May 28, 2026

Addendum No. 1

PROJECT: Dallesport Industrial Rail Spur Project #2026-02
Port of Klickitat

SHEET
C000

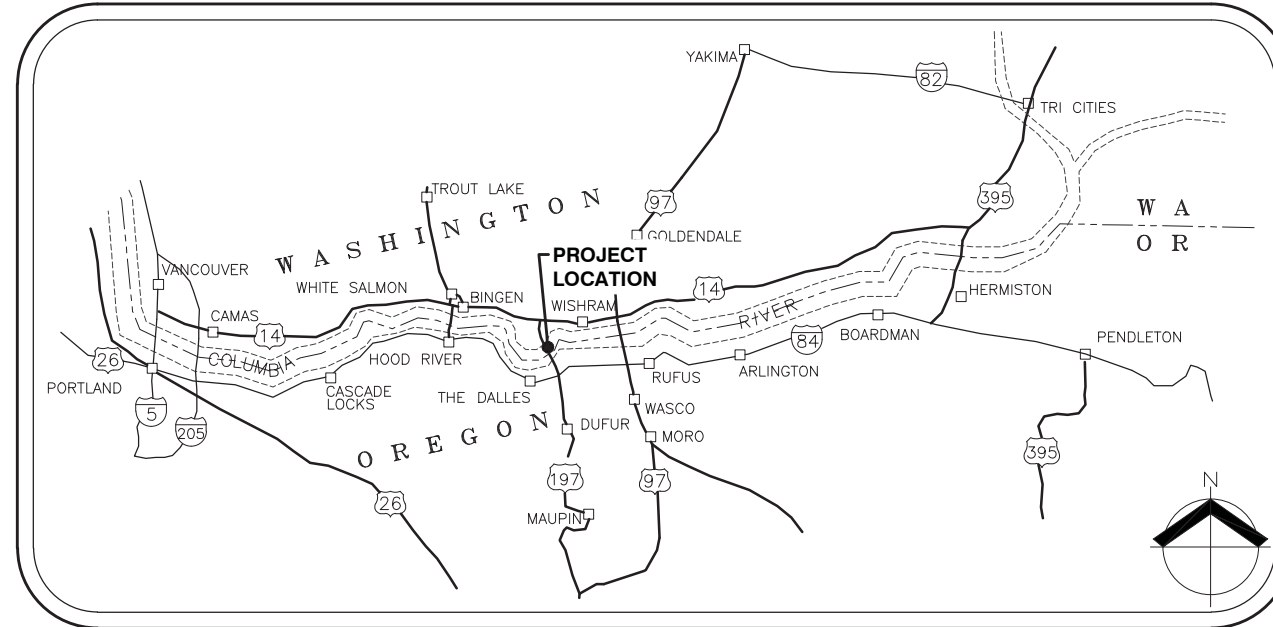
1. *Sheet C000:* Remove and replace with attached Sheet C000, dated May 28, 2026. Project area has been expanded to include switch on the south side of Dock Road.
